NEW YORK STATE DEPARTMENT OF ENVIRONMENTAL CONSERVATION

**Re: IRM Work Plan
Former Alliance Metal Stamping and Fabrication Site #c828101
Gates, Monroe County**

The New York State Department of Environmental Conservation (NYSDEC), in consultation with New York State Department of Health, has completed its review of the document entitled "IRM Work Plan" for Former Alliance Metal Stamping & Fabrication Facility Site #828101, dated 28 June 2019, and approve with the following modifications:

SUB-SLAB DEPRESSURIZATION SYSTEM COVERAGE PLAN

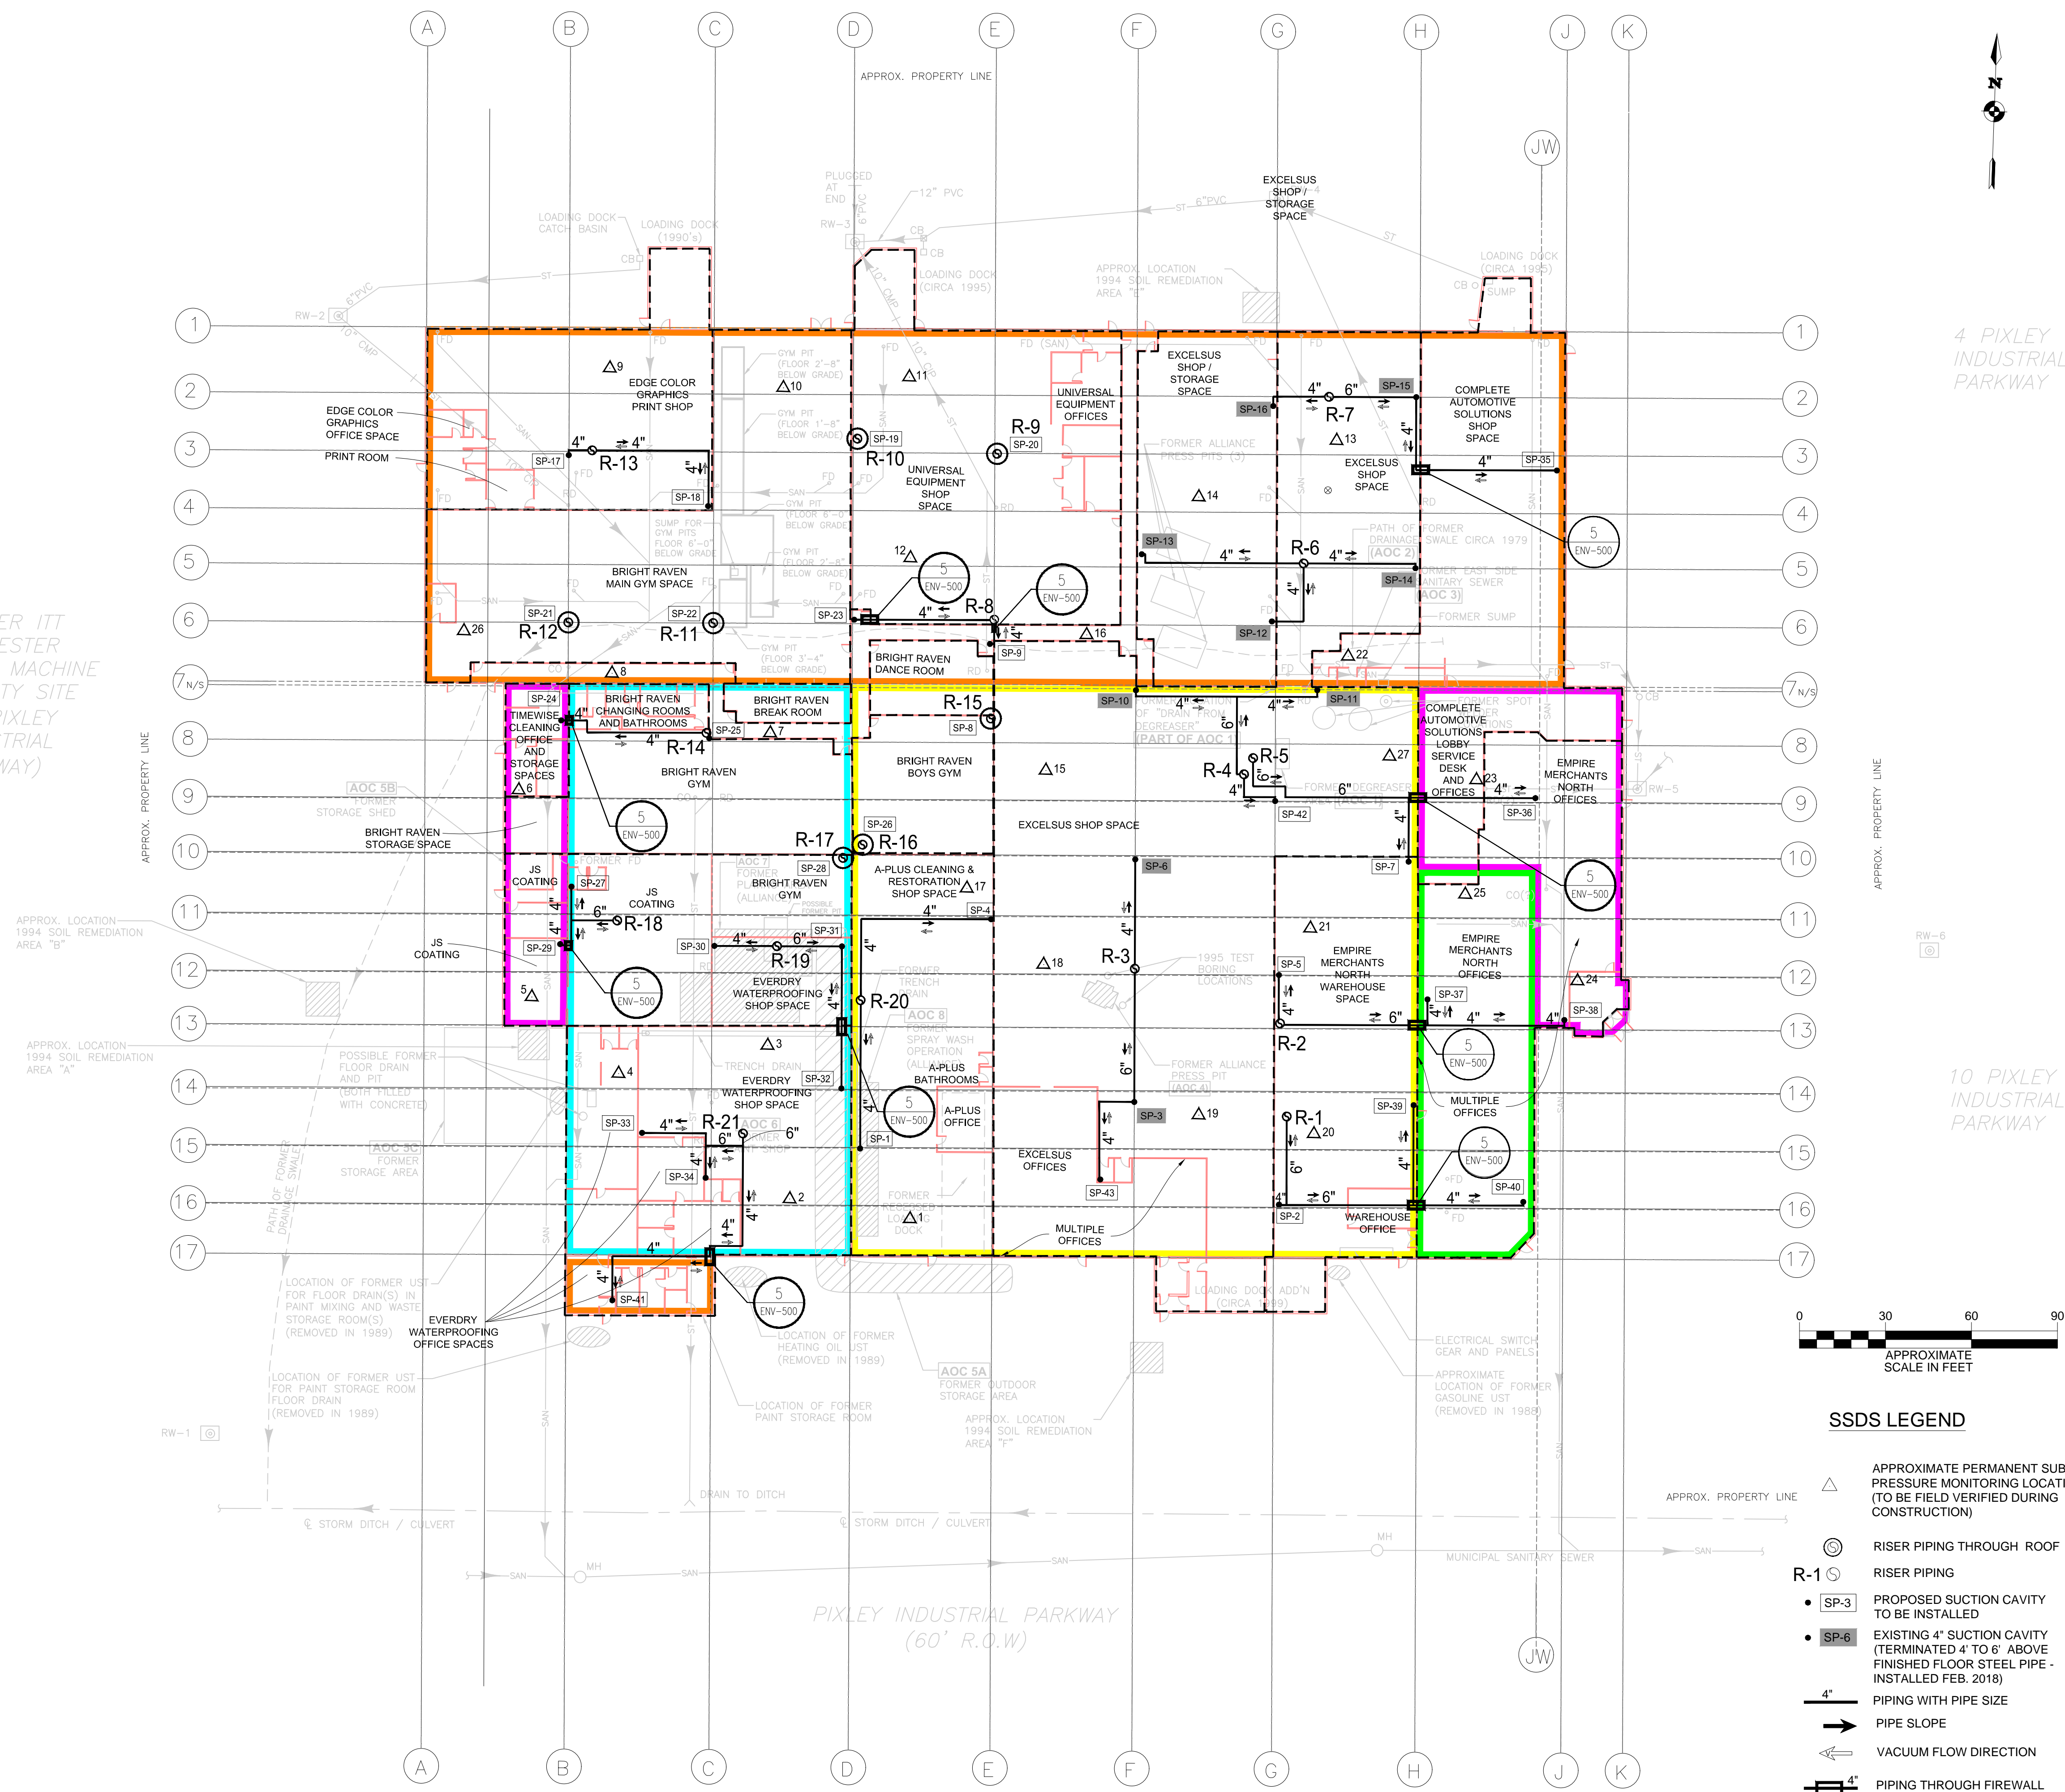
- (1) Bright Raven Gymnastics
 - (2) Excelsus / Former vapor degreaser area
 - (3) Complete Automotive
 - (4) Universal Equipment
- 4) Appendix A – SSDS Design – Drawing No. ENV-100

- a) The following clarification is part of the approved version:

- i) Pressure field extension testing must be added in
 - (1) Bright Raven Gym
 - (2) Bright Raven Boys Gym
 - (3) Bright Raven Dance Room
 - (4) Bright Raven Main Gym Space (additional)
 - (5) JB coating
 - (6) Complete Automotive Shop
 - (7) Excelsus
